FIELD SERVICE BULLETIN***FS-2019-03: Battery Fuse Change***

Date: May 29, 2019
Model: Hybrid
Model Years: 2013 - 2015

59-74282-001

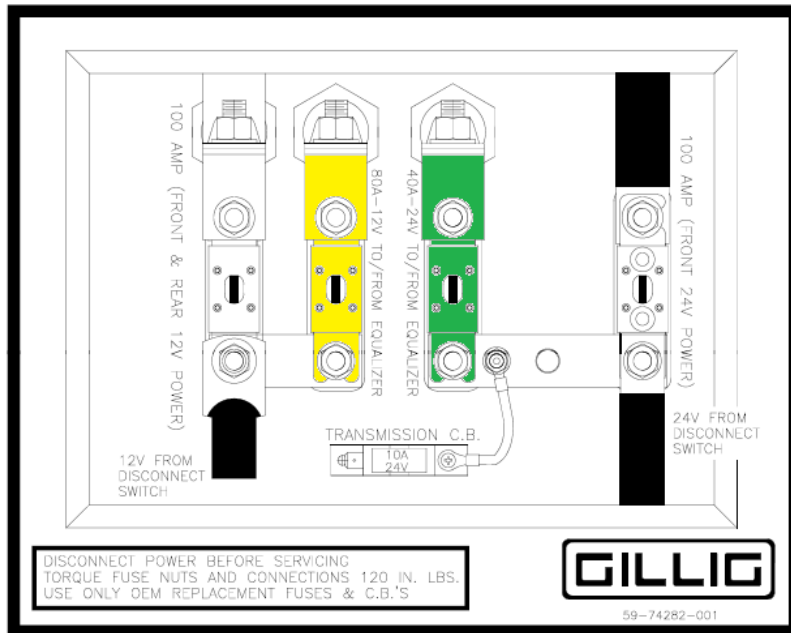
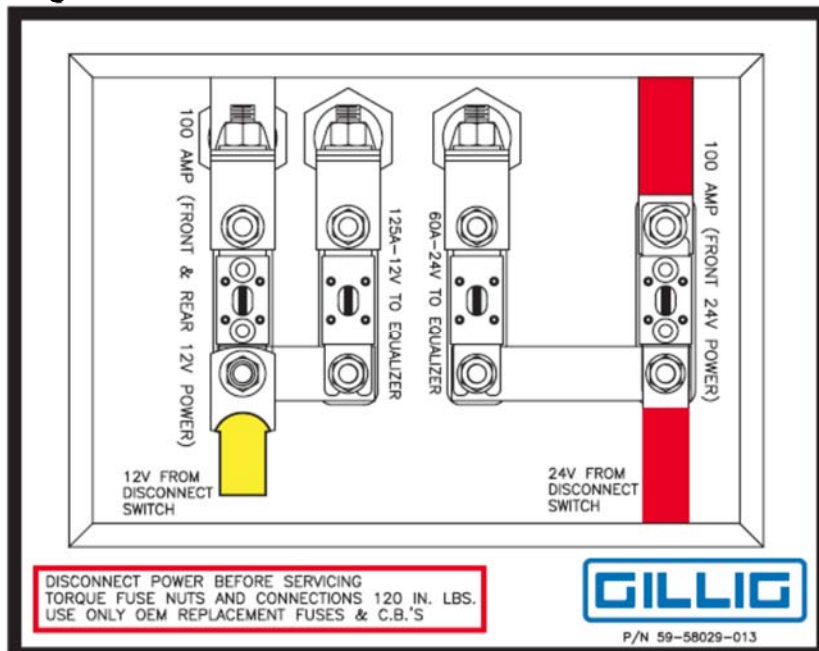
After a review of the fuse selection in some of your 2013 through 2015 Hybrid buses, Gillig determined that the fuses in the battery fuse box need to be changed.

In addition, we will be sending you a replacement decal for the door on this box to match the correct fuses.

You should remove the 125 Amp Fuse for the 12 Volt to/from the Equalizer and replace it with the 80 Amp Fuse.

Remove the 60 Amp Fuse for the 24 Volt to/from the Equalizer and replace it with the 40 Amp fuse.
